Access Compliance Report

Public Rights-of-Way

Intersection ID: 13780	Main Street: ELIZABETH_AV	Cross Street: N_TORRENCE_ST	Location: W
ADA ID: 8AEC1EC98188	Ramp Type: Perp	Initial Pass/Fail: Fail	Overall Compliance: No
		Severity Score: 8.75

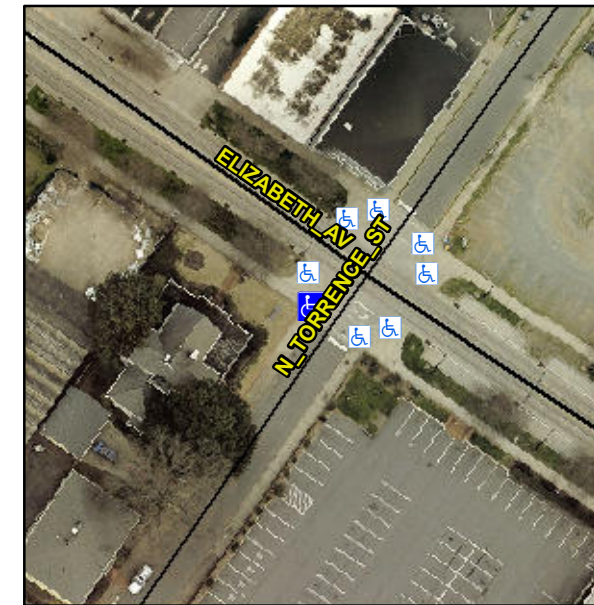
Not Found, R304.5.1

Compliance	Description	Data	Compliance	Description	Data
N/A	Ramp Length (in)	74.0	Yes	Ramp Slope (%)	5.7
No	Ramp Width (in)	47.5	Yes	Ramp XSlope (%)	2.0
N/A	Flare Type LT	N/A	N/A	Flare Type RT	N/A
N/A	Flare Slope LT (%)	N/A	N/A	Flare Slope RT (%)	N/A
N/A	Flare Traversable LT?	N/A	N/A	Flare Traversable RT?	N/A
N/A	Landing Length (in)	N/A	N/A	DWS Provided?	N/A
N/A	Landing Width (in)	N/A	N/A	DWS Contrast?	N/A
N/A	Landing Slope (%)	N/A	N/A	DWS Length (in)	N/A
N/A	Landing X Slope (%)	N/A	N/A	DWS Full Width?	N/A
N/A	Landing Curb? (Y/N)	N/A	N/A	DWS Offset (in)	N/A
N/A	Shared Landing?	N/A			
N/A	Gutter Ponding?	N/A	N/A	Gutter Slope (%)	N/A
N/A	Gutter Lip Ht (in)	N/A	N/A	Gutter X Slope (%)	N/A
N/A	Painted X Walk1?	Yes	N/A	Painted X Walk2?	N/A
	X Walk 1 Direction	To SE		X Walk 2 Direction	N/A
N/A	X Walk 1 Width (in)	116.5	N/A	X Walk 2 Width (in)	N/A
	X Walk 1 Slope (%)	4.7		X Walk 2 Slope (%)	N/A
	X Walk 1 X Slope (%)	1.2		X Walk 2 X Slope (%)	N/A

Remove & Replace Entire Ramp.
